SERVICE BULLETIN No.1126

COACH MODEL	: C2045
BULLETIN TYPE	: Safety Recall Program – NHTSA Campaign number 04V-422
MANUAL & SECTION	: N/A
PARTS BOOK REVISION	: No
DATE	: December 3, 2004
SUBJECT	: Main junction box – top cover
TERMS & CONDITIONS	: Refer to the Warranty Information in this Bulletin.

Figure 2: Open top J-box

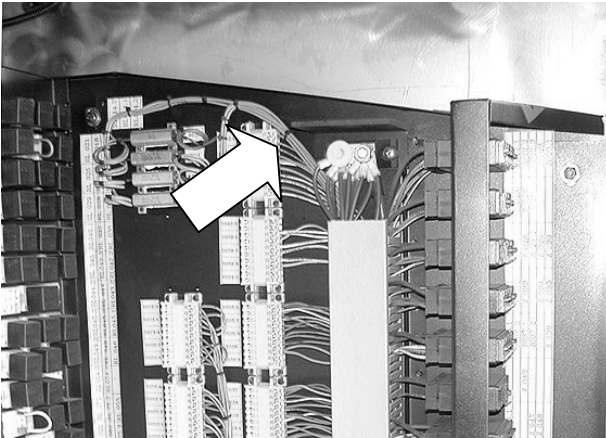
On the above-mentioned coaches, it is necessary to add a closing panel to the top of the left hand and right hand sections of the main junction box in order to prevent possible damage to electrical components.

- 2) Check the junction box for the presence of a closing panel (see Figure 2).

Figure 4: Cover VH 10861312 installed

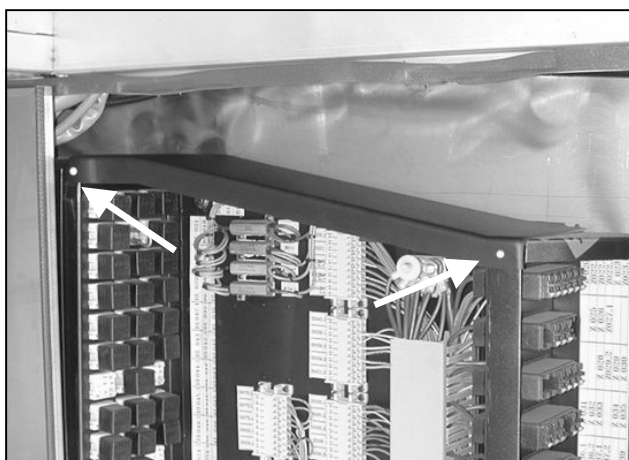
- 4) At the corners, secure the molding to the junction box channels with two sheet metal screws VH 660280110 (see Figure 4).
